RE: **Lot 14 Block 7A Unit 3 SAD 227**  
**6309 Little Joe Rd. NW**  
**Grading and Drainage Plan**  
**Engineers Stamp Date 8/14/2021 (E10D109)**  
**Pad Certification Date 9/3/2021**

Based upon the information provided in your submittal received 9/8/2021, this plan is approved for Building Permit.

ENGINEER'S SEAL 	LOT 14 BLK 7A UN 3 VC 6309 LITTLE JOE	DRAWN BY DEM
	GRADING AND DRAINAGE PLAN	DATE 8-14-21
 P.O. BOX 53924 ALBUQUERQUE, NM 87199 (505) 321-9099		Lot 14 Blk 7a Un 3 VC.DWG
		SHEET # C1
DAVID SOULE P.E. #14522		JOB #

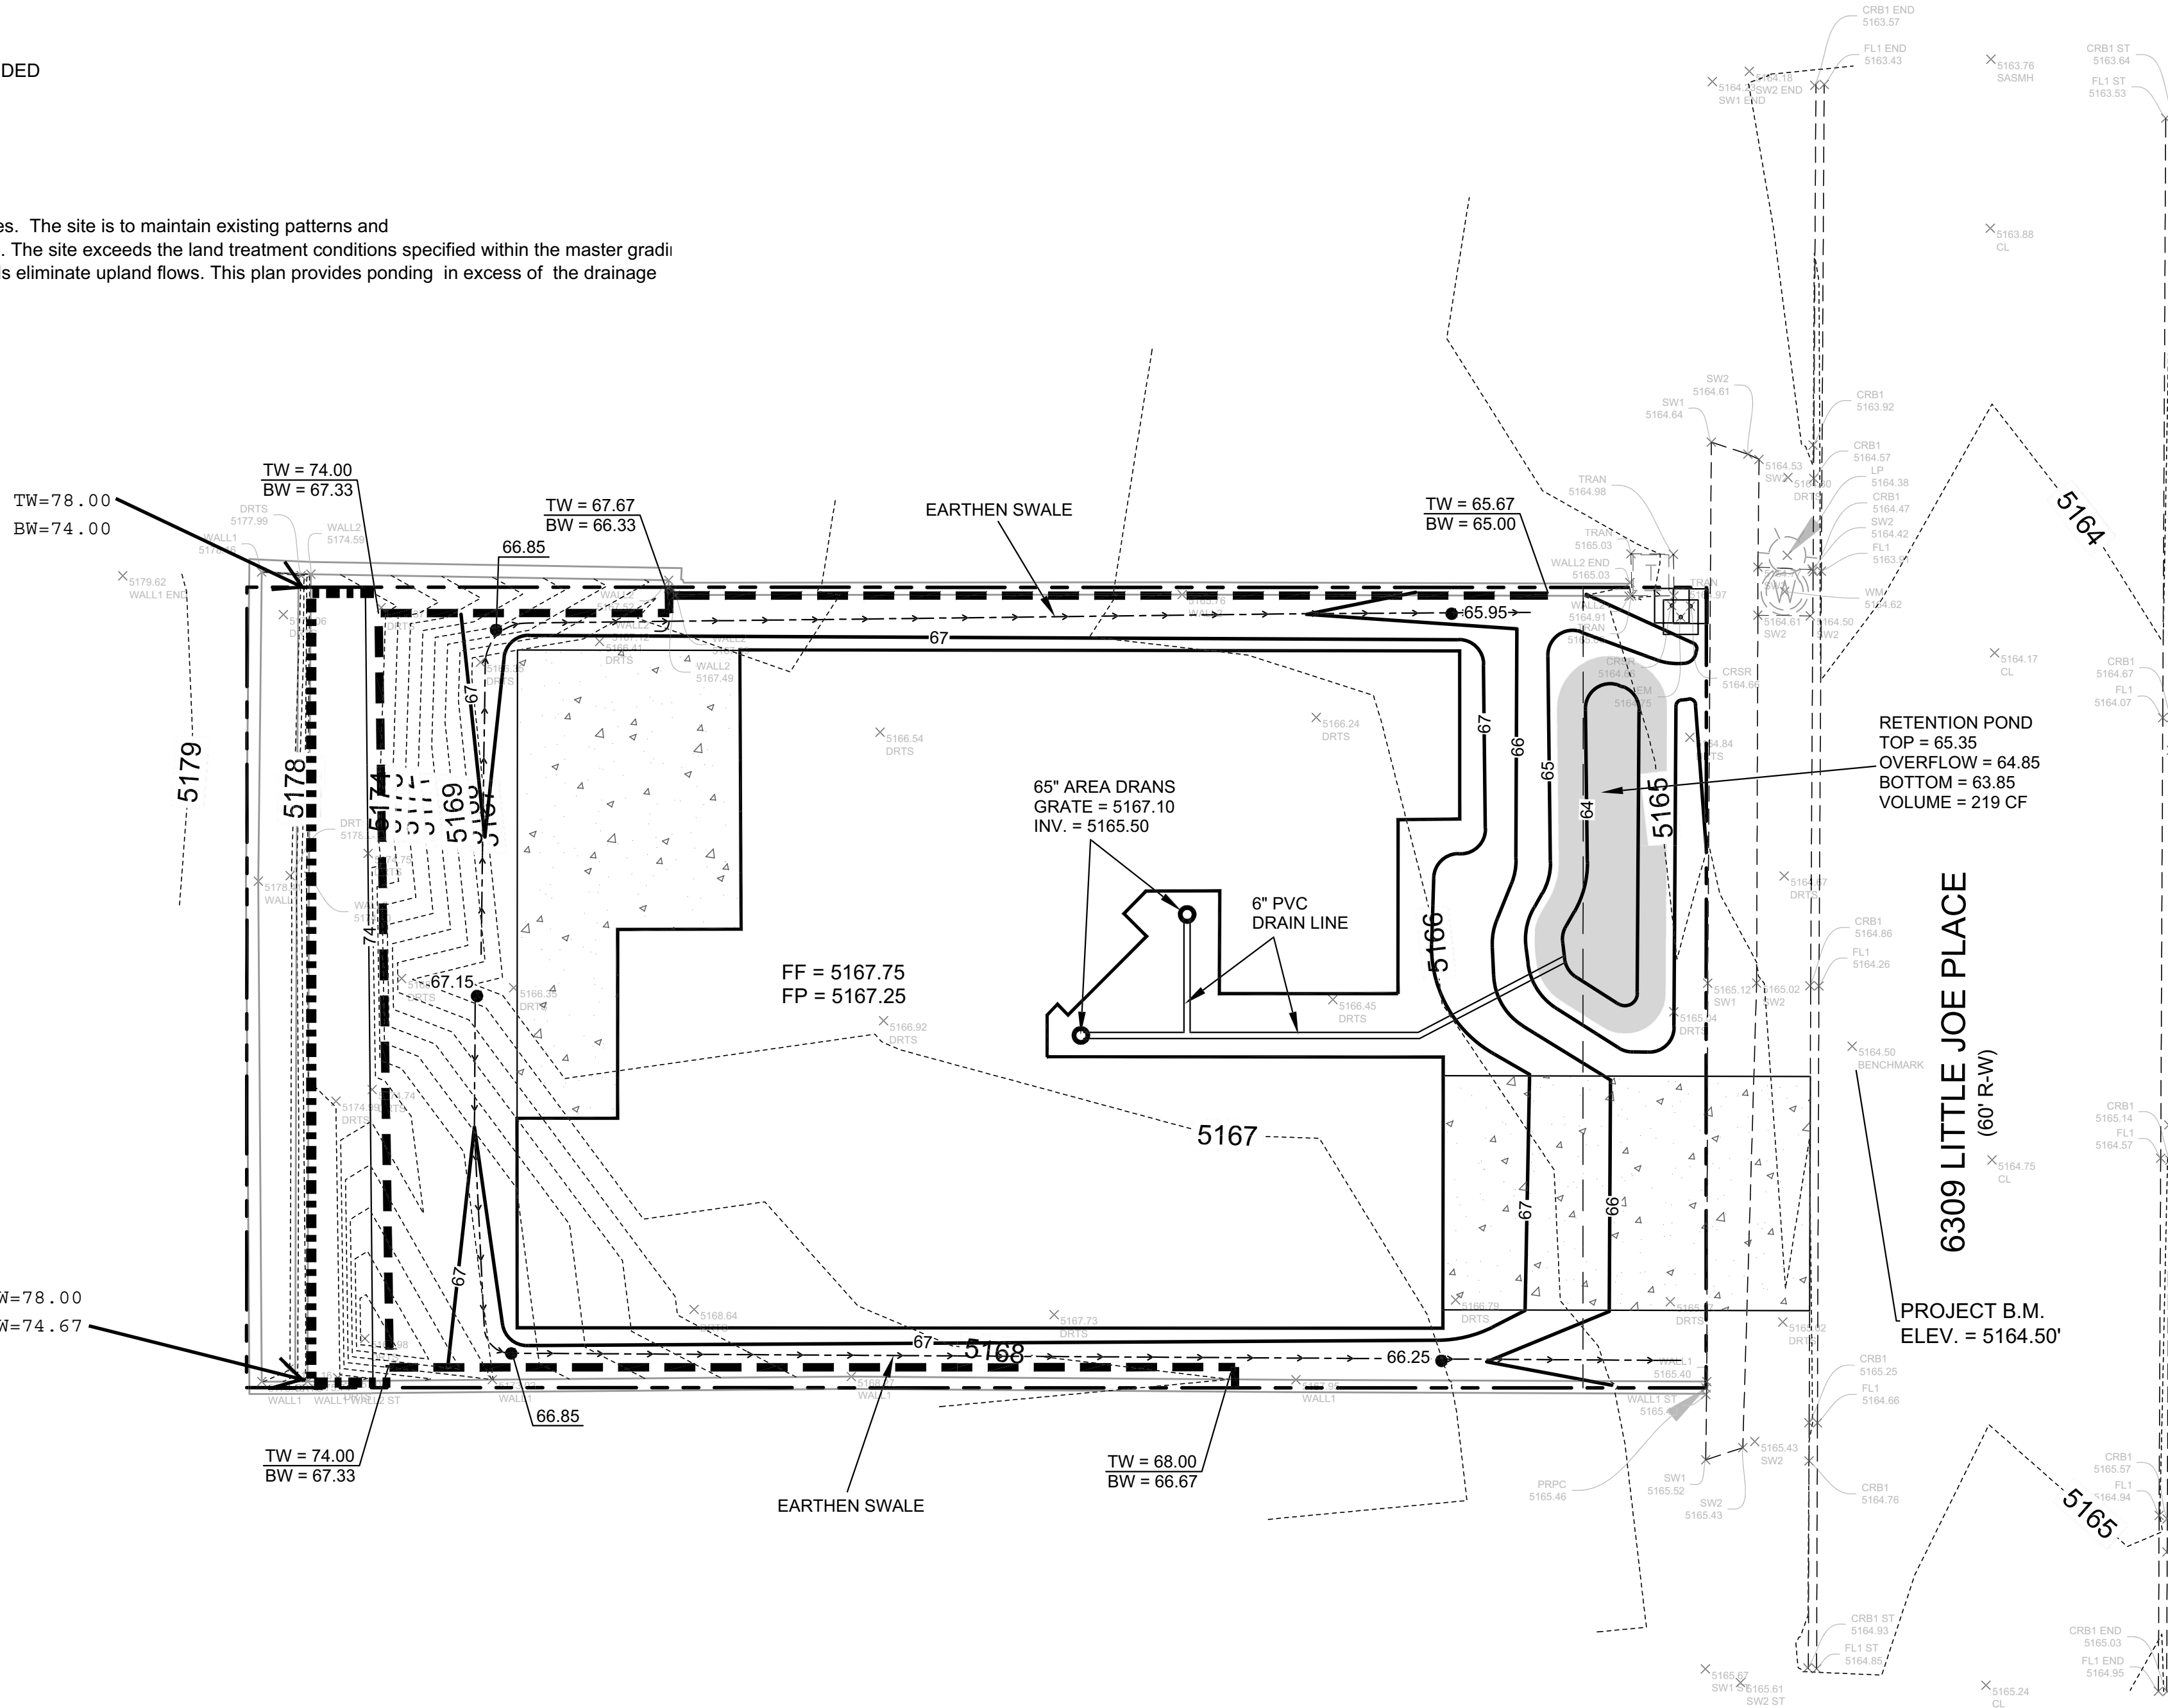
**Reiterate to the Owner/Contractor that a separate permit for a garden/retaining wall must be obtained, with the approved G&D plan. Also, advise the owner/contractor not to use dirt as a ramp to climb the curb. If dirt is used it will cause a delay in permitting.**

Prior to Certificate of Occupancy release, Engineer Certification per the DPM checklist of this plan will be required.
